1822 Bank Street

URBAN DESIGN BRIEF

RESPONSE TO URBAN DESIGN COMMENTS

Open Space

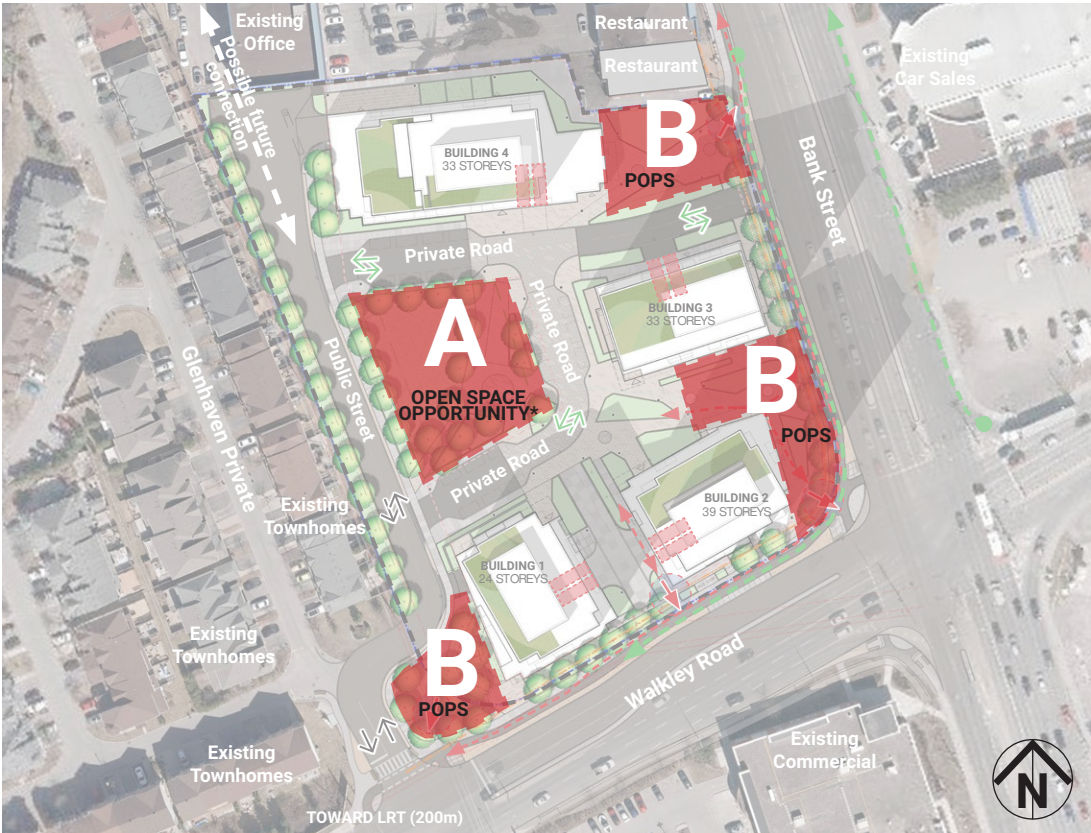
- k. The park
 - Surrounded by roads on all four sides and residential fencing on the west side, the quality and experience of the park remain unconvincing.
 - There is very limited visibility from either Bank Street or Walkley Road.

39. Design a functional, animated, bright, and visible park with optimal microclimate conditions year-round.

Applicant: We are only proposing a public road on the north and west side of the park. This responds to the City requirements that all new parks abut a public road. The Private Road on the south and east side are intended to serve only for the requires of loading / drop off and will not carry significant vehicle traffic. These will be designed as low-speed, pedestrian priority spaces (woonerf or living street) – effectively an extension of the hard landscaping from the proposed building faces to the greenspace.

Applicant: Noted. We have brought Ferris + Associates Landscape Architects onto our team to help guide the development of the outdoor hard and soft landscape spaces.

INTERIOR STREETS

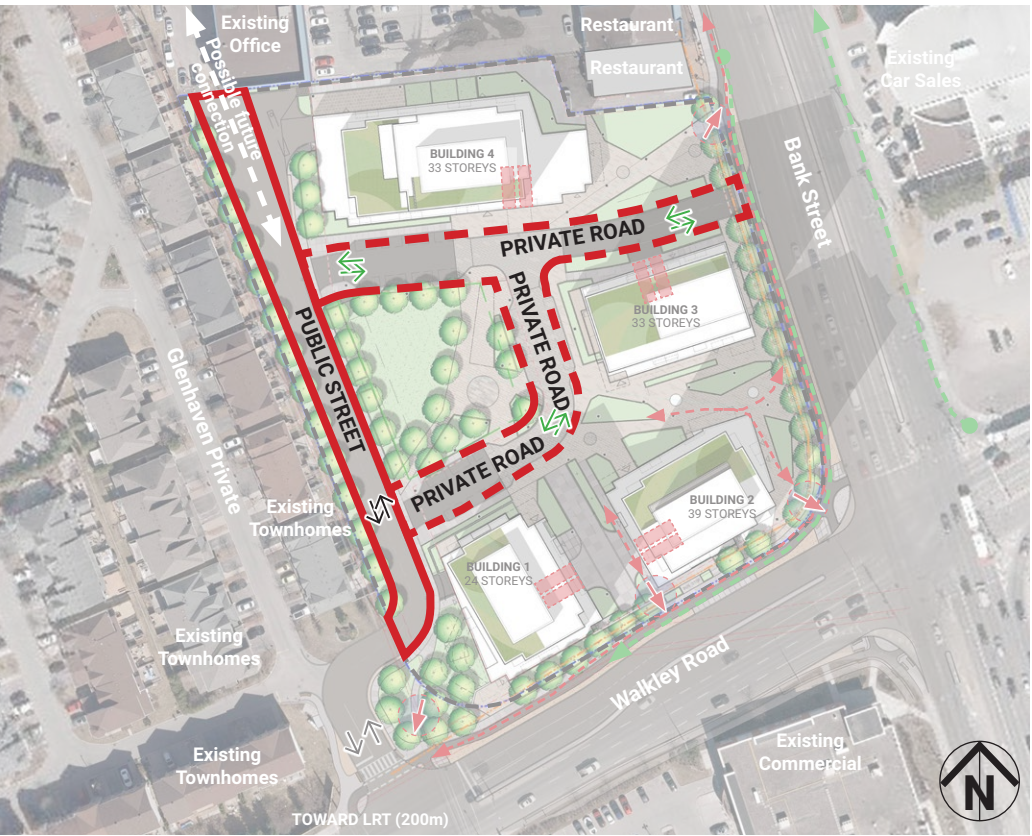
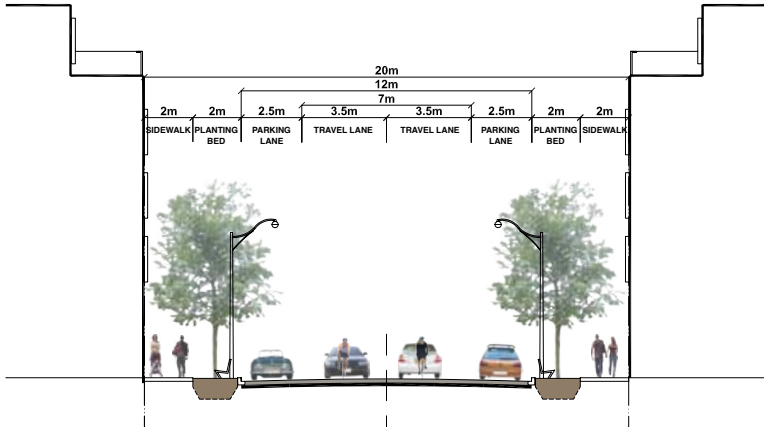
- g. The complicated, irregular, and potentially unsafe design at Walkley, Glenhaven, West Valley, and the proposed new public street intersection. The new public street makes a sharp turn within a short distance from an existing complicated intersection. The condition is further complicated by the location of the loading and parking ramp of Building 5.

40. Ensure street design is safe and satisfies practical requirements.

Applicant: The primary issue with the Glenhaven, West Valley and new street intersection is the length of the throat to Walkley Road. Our traffic engineers are reviewing options for improvements to the design of the intersection to address existing and new traffic volumes.

Applicant: Noted. Our priorities for the streets (public and private) are to ensure controlled traffic volumes, minimize or eliminate commuter cut through, control speed, and ensure the most inviting pedestrian environment.

VIEW FROM ABOVE NORTHWEST SHOWING 45 DEGREE ANGULAR PLANE

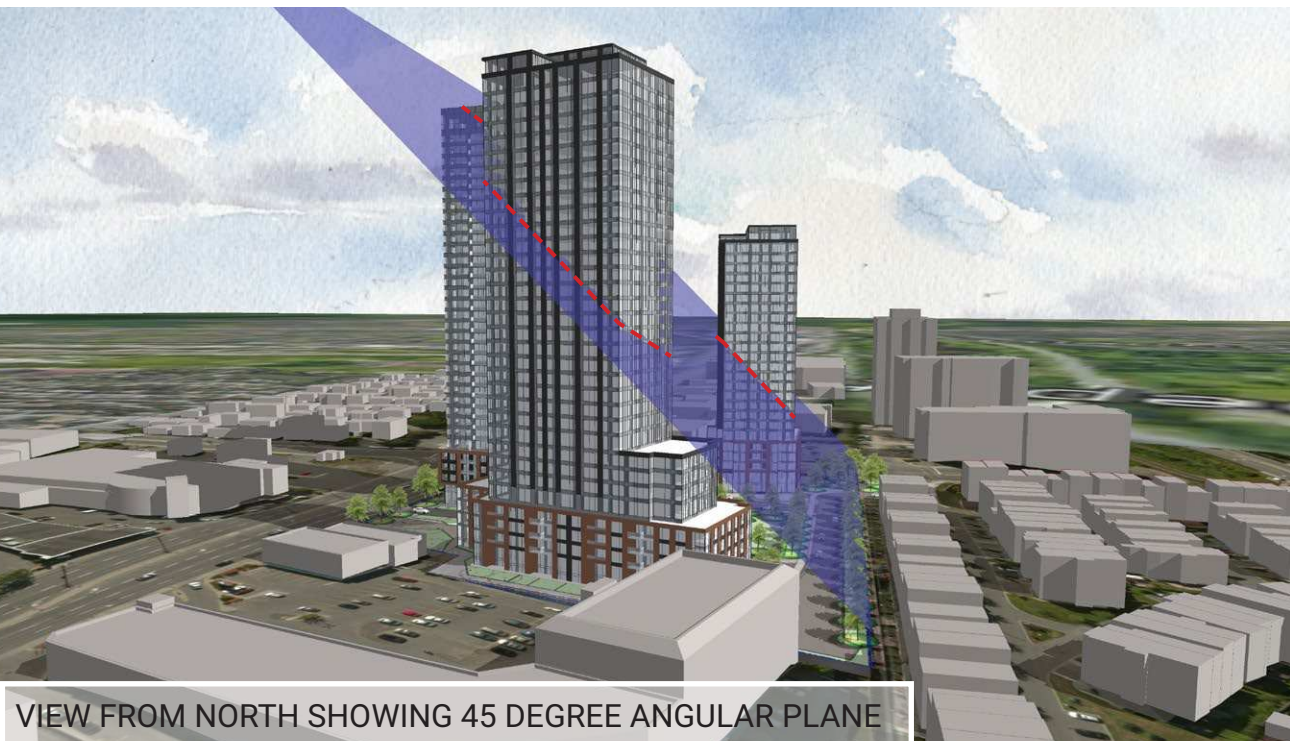
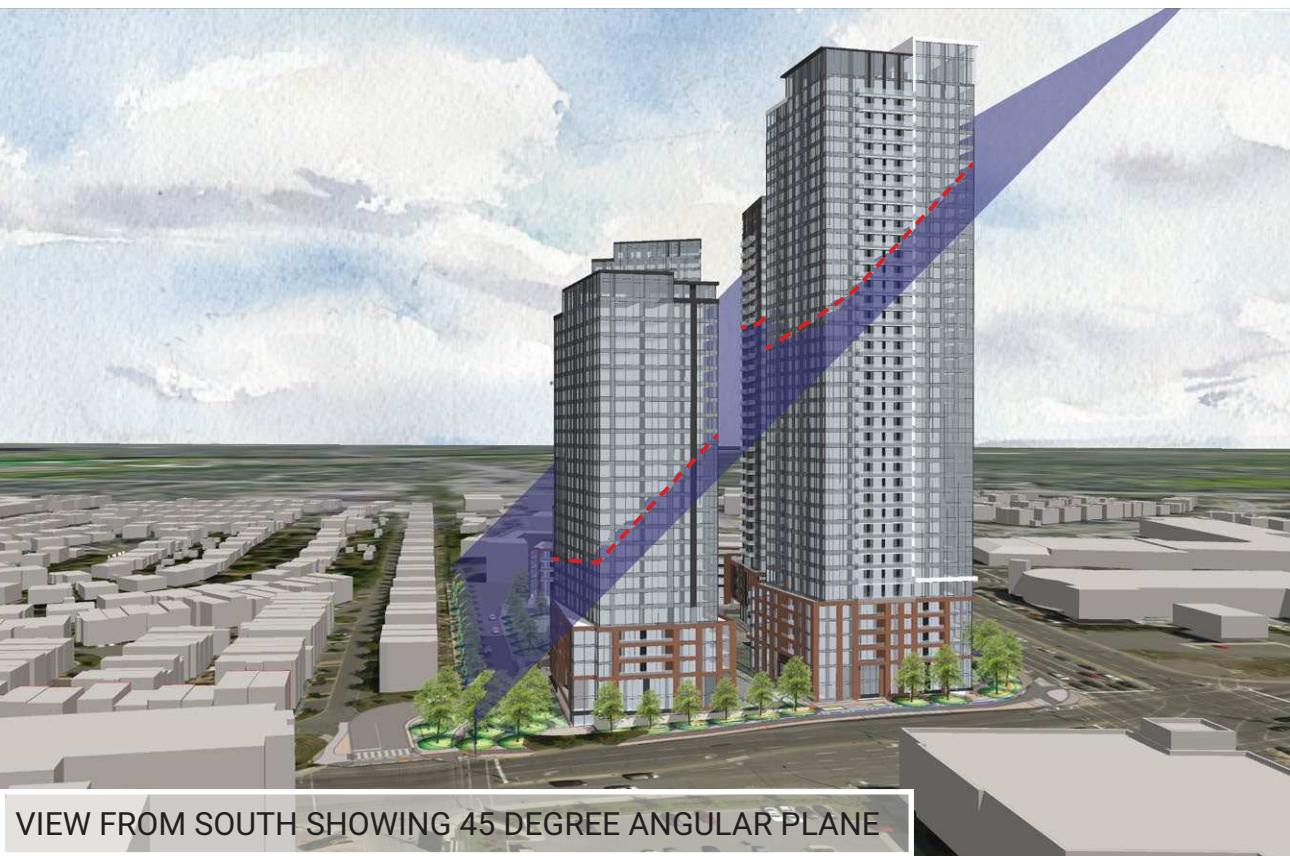
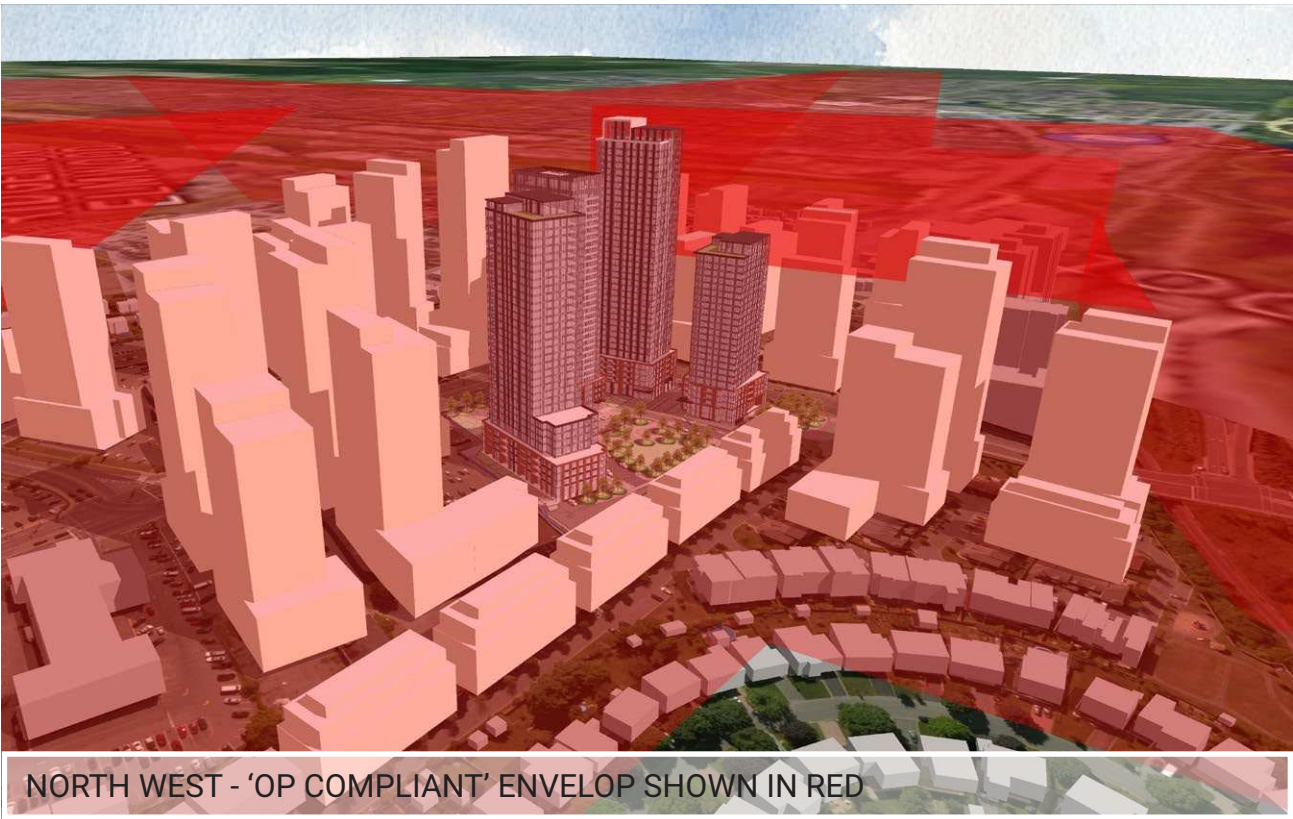
41. Ensure effective built form transition, guided by the application of angular planes.

Applicant: Please refer to the angular plane diagrams included in the UDRP submission set. We feel that the proximity to the transit station and future development potential under the OP justifies some elements of the development breaking the 45 degree angular planes. The trade-off the proposed development offers is providing the majority of the western edge as greenspace. This minimizes the number of the existing townhomes impacted by overlook / shadowing.
